World Forum for Harmonization of Vehicle Regulations

Working Party on Passive Safety

Regulation No. 14 (Safety-belt anchorages)

Proposal for Supplement X to the 07 series of amendments

Figure 1: 3D view of the support leg foot assessment volume

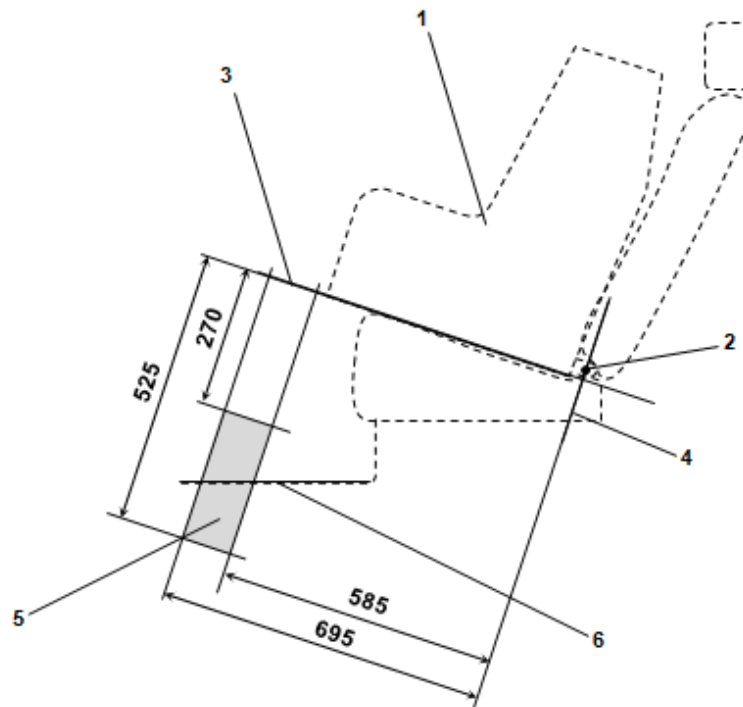
Add a new Annex 10:

- 1 Child Restraint Fixture (CRF)
- 2 ISOFIX low anchorages bar
- 3 Median longitudinal plane of the CRF
- 4 Support leg foot assessment volume
- 5 Vehicle floor contact surface

In addition to the requirements defined in 5.2.3. and 5.2.4. it shall be verified that the upper surface of the vehicle floor (incl. trim, carpet, foam, etc.) intersects with both of the limiting surfaces in x- and y-direction of the support leg foot assessment volume, as shown in figure 1 and 2 of annex 10 of this Regulation.

The support leg foot assessment volume is characterized as follows (see also annex 10, figure 1 and 2 of this Regulation):

- In width by two planes parallel to and 100mm apart from the median longitudinal plane of the child restraint fixture installed in the respective seating position; and

- In length by two planes perpendicular to the plane given by the child restraint fixture bottom surface and perpendicular to the median longitudinal plane of the child restraint fixture, 585mm and 695mm apart from the plane passing through the centerlines of the ISOFIX lower anchorages and being perpendicular to the CRF bottom surface; and

- In height by two planes which are parallel to and 270mm and 525mm below the child restraint bottom surface.

Figure 2: Side view of the support leg foot assessment volume

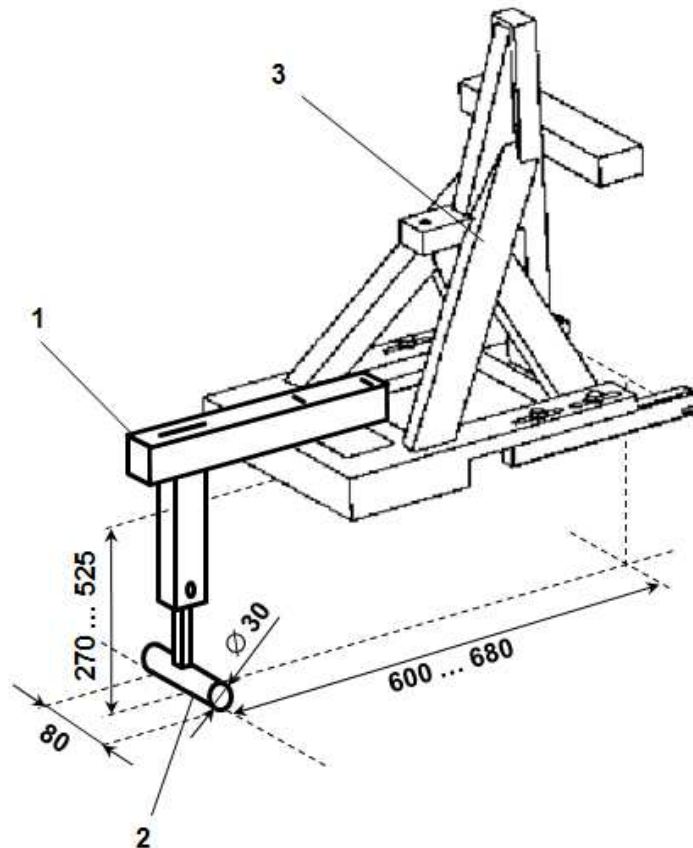
- 1 Child Restraint Fixture (CRF)
- 2 ISOFIX low anchorages bar
- 3 Plane formed by the bottom surface of the CRF when installed in the designated seating position
- 4 Plane passing through the lower anchorage bar and oriented perpendicular to the median longitudinal plane of the CRF and perpendicular to the plane formed by the bottom surface of the CRF when installed in the designated seating position
- 5 Support leg foot assessment volume in which the vehicle floor has to be located in. This volume represents the length and height adjustment range of an i-Size child restraint system support leg.
- 6 Vehicle floor

Figure 3: Example for a modified Static force application device with support leg test probe (SFAD_{SL}) showing the required adjustment range and dimensions of the support leg foot

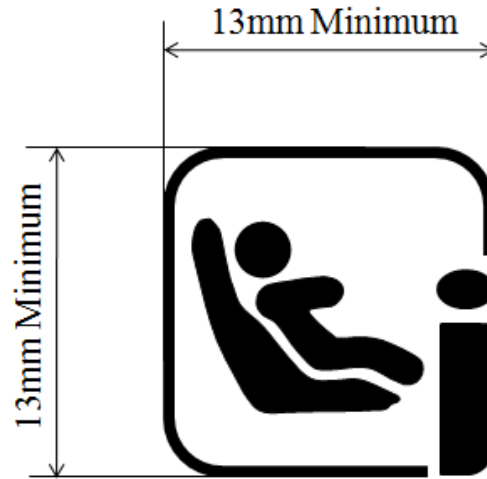
1. Drawing not to scale.
2. The support leg test device shall:
 - ensure testing within the whole vehicle floor contact surface defined for an individual i-Size seating position.
 - be rigidly fixed to the SFAD so that the forces applied to the SFAD will directly induce test forces into the vehicle floor, without reduction of the reactive test forces due to damping within or deformation of the support leg test device itself
3. The support leg foot shall consist of a cylinder, having a width of 80mm, a diameter of 30mm and on both side faces rounded edges with a 2.5mm radius
4. In case of incremental height adjustment the distance between the steps for adjustment shall not be more than 20mm

In addition to the tests specified in 6.6.4.3. and 6.6.4.4. a test with a modified static force application device, which consists of an SFAD and includes a support leg test probe as defined in figure 3 of annex 10, shall be performed. The support leg test device shall be adjusted in length and width to assess the vehicle floor contact surface, as defined in paragraph 5.2.5.2. (see also figure 1 and 2 of annex 10 of this Regulation). The height of the support leg test device shall be adjusted in the way that the foot of the support leg test device is in contact with the upper surface of the vehicle floor. In case of incremental height adjustment the first notch where the foot rests stable on the floor shall be chosen, in case of a non-incremental/continuous adjustment of the support leg test device height the pitch angle of the SFAD shall be increased by 1.5 +/- 0.5 degrees due to the height adjustment of the support leg test device.

The horizontal excursion (after pre-load) of point X of the SFAD during application of the 8 kN ± 0.25 kN force shall be limited to 125 mm and permanent deformation including partial rupture or breakage of any ISOFIX low anchorage and the vehicle floor contact surface, or surrounding area shall not constitute failure if the required force is sustained for the specified time."
